Plug Abandonment NOI Proposed

OPERATOR NAME: Bar V Barb, LLC

WELL NAIME & NO.: South Lucky Lake Queen Unit #2B

South Lucky Lake Queen Unit 2B 30-005-60375 Mack Energy Corporation October 19, 2021 Conditions of Approval

Bar V Barb, LLC		Proposed		
Author:	Abby @ BCM			
Well Name	South Lucky Lake Qn Unit	Well No.	#2B	
Field/Pool		API#:	30-005-60375	
County	Chaves	Location:	Sec 22, T153, R29E	
State	New Mexico		990 FSL & 330 FWL	
Spud Date	4/3/1976	GL:		
	*

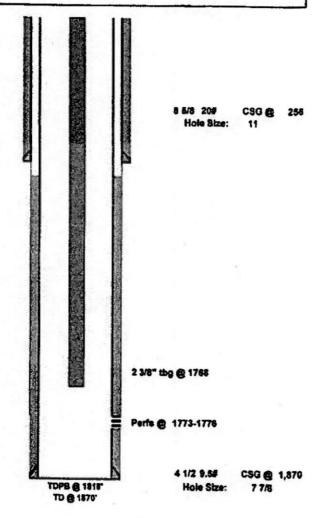
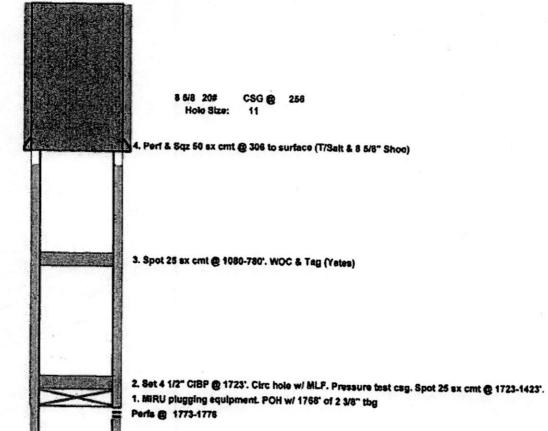
- 1. Operator shall place CIBP at 1,723' (50'-100' above top most perf) and place 25 sx of Class C cement on top as proposed. WOC and TAG.
- 2. Operator shall place a Class C cement plug from 1,080'-780' to seal the Yates Formation and the Bottom of the Salt.
- 3. Operator shall perf at 306' and squeeze class C Cement to surface to seal the top of Salt and the 8-5/8'' casing shoe.
- 4. Surface reclamation will need to be completed once the well bore has been plugged. Please contact <u>rflores@blm.gov</u> for additional information.
- 5. See Attached for general plugging stipulations.
